RIVERCHASE ARCHITECTURAL COMMITTEE  
RESIDENTIAL REVIEW FORM *264*

OWNER/BUILDER Park Lane Properties DATE RECEIVED July 18 '89  
SUBDIVISION PCE 27 LOT 2703  
SUBMITTED BY Carthay Mason  
TITLE OF PLANS \_\_\_\_\_ DESIGNER \_\_\_\_\_

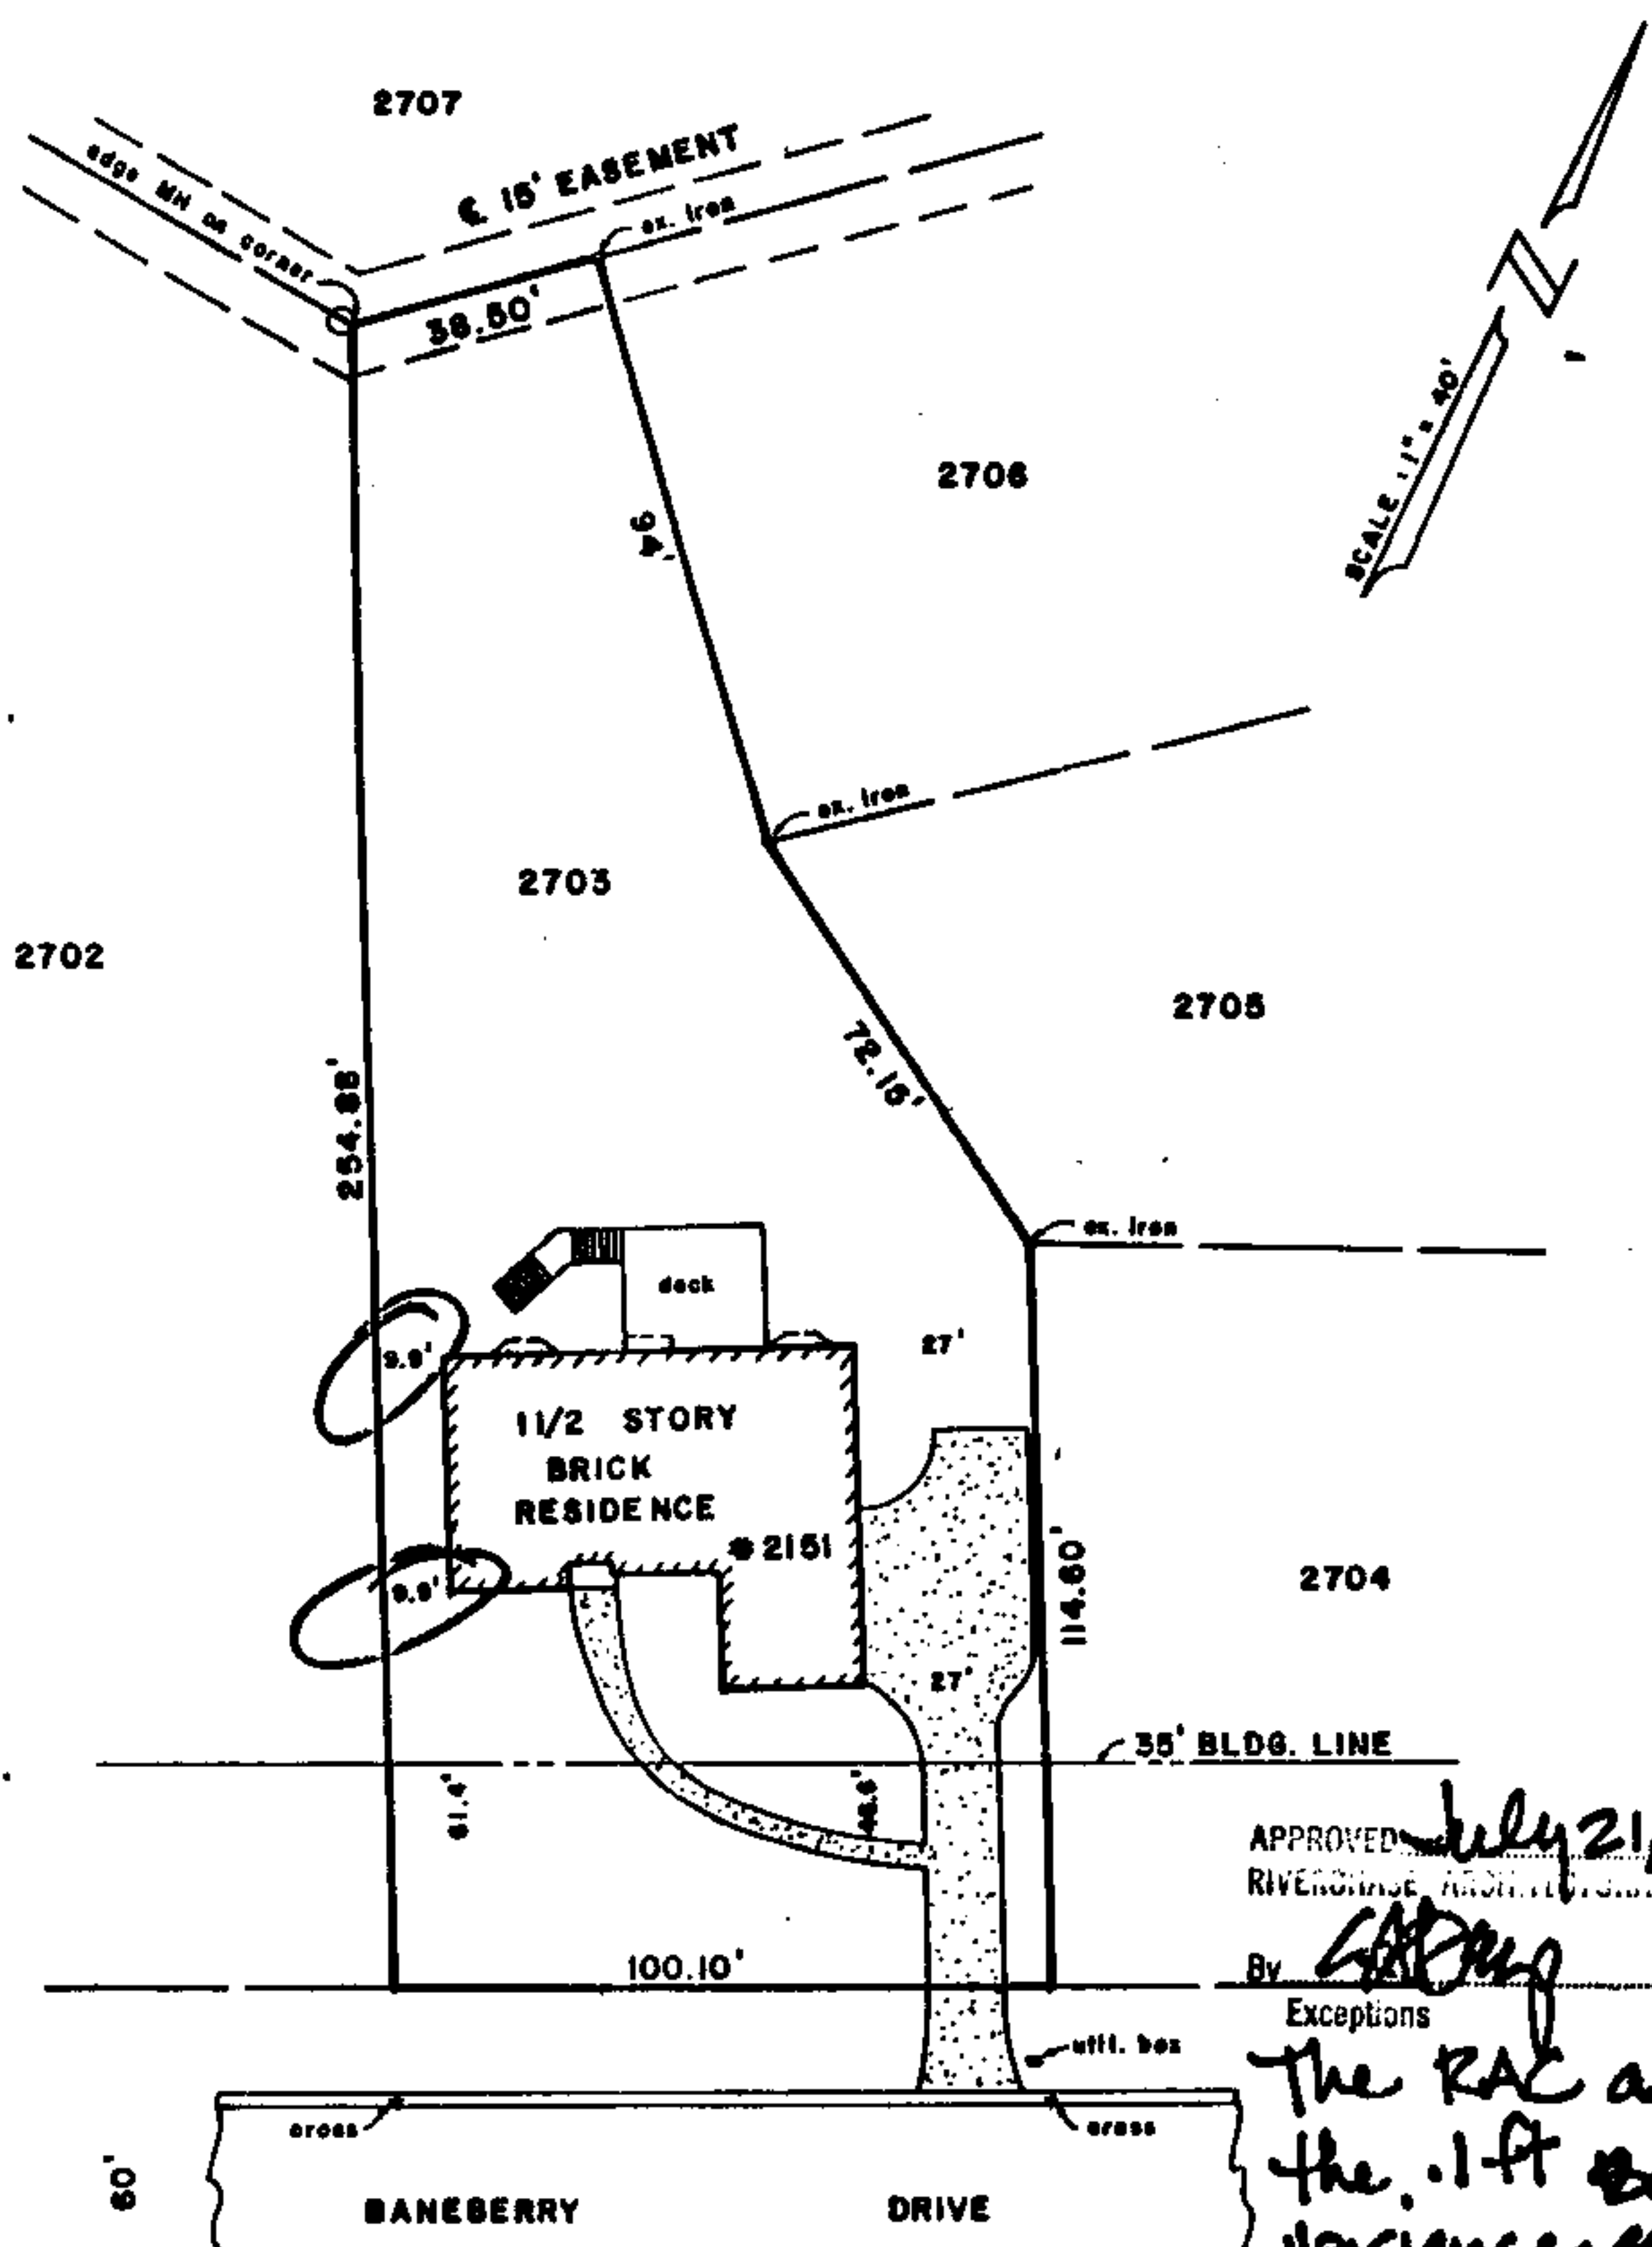
By [Signature]  
Exceptions  
The RAC approves  
the .1 ft setback  
variance as  
indicated
